SUNDRY NOTICES AND REPORTS ON WELLS

1. Type of Well Soil Well	8. Well Name and No.					
2. Name of Operator Pogo P	roducing Company			Pure Gol 9. API Wel	d A Federal #12	
3a Address P.O. Box 10340, Midland, TX 79702 3b. Phone No. (include area code) 432-685-8100					30-015-35303 10. Field and Pool, or Exploratory Area

Pure Gold "A" Fed #11 & 12 CHOKE MANIFOLD

Pure Gold "A" Fed # 11 & 12 BOP SCHEMATIC

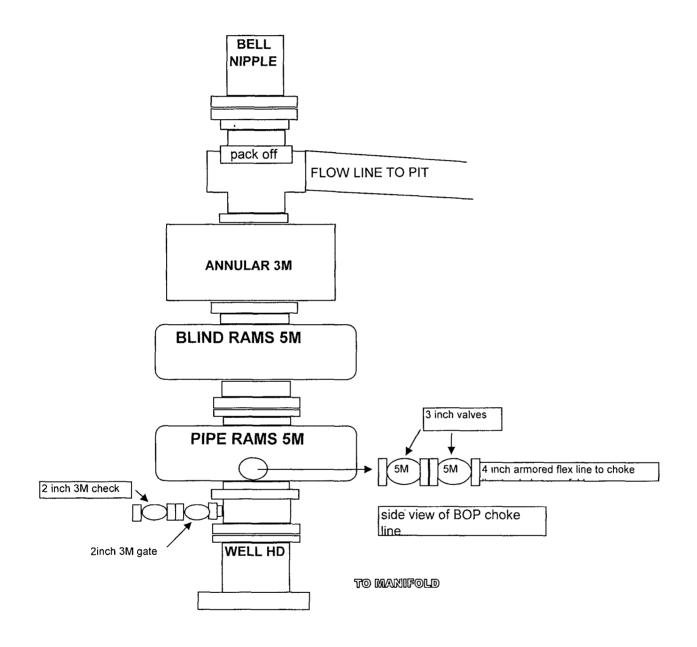
12. CHECK A	PPROPRIATE BOX(ES) TO	INDICATE NATURI	E OF NOTICE, R	EPORT, OR	OTHER DATA	
TYPE OF SUBMISSION	TYPE OF ACTION					
Notice of Intent Subsequent Report Final Abandonment Notice	Acidize Alter Casing Casing Repair Change Plans Convert to Injection	Deepen Fracture Treat New Construction Plug and Abandon Plug Back	Production (St Reclamation Recomplete Temporarily Al Water Disposal	bandon	Water Shut-Off Well Integrity Other	
If the proposal is to deepen din Attach the Bond under which following completion of the in testing has been completed. Find determined that the site is read Pogo Producing Compwell. A rotary rig will be psi WP hose for the chup time thus saving more on each end. The chemax surface pressure 2000 psi BOPE is all that per described in the SEE ATTAC	ectionally or recomplete horizontall the work will be performed or provivolved operations. If the operation in Abandonment Notices shall be y for final inspection.) The any respectfully request the substituted for the tooke line in the drilling oney with out a safety oke manifold is as designed should be ± 1800 psinat is needed in this were 2,000 psi rule in Ons	ly, give subsurface location ide the Bond No. on file w results in a multiple complified only after all required est a change of pop drive rig. We of the well. This problem. The hocribed in attachm as prescribed in ell. The rig does hore Order 2.	s and measured and trith BLM/BIA. Requiretion or recompletion ments, including reclandance for the drawould like to use rig equipments itself is rathernt. This we onshore orde	ne vertical depth red subsequent re in a new interval nation, have been rilling of the utilize an a ent and wi ted to 10k Il is to be or r # 2 show	e above captioned rmored 4 inch 3000 ll help quicken nipple but has 3k flanges drilled to 8200 ft and mas .22 psi/ft. Thus
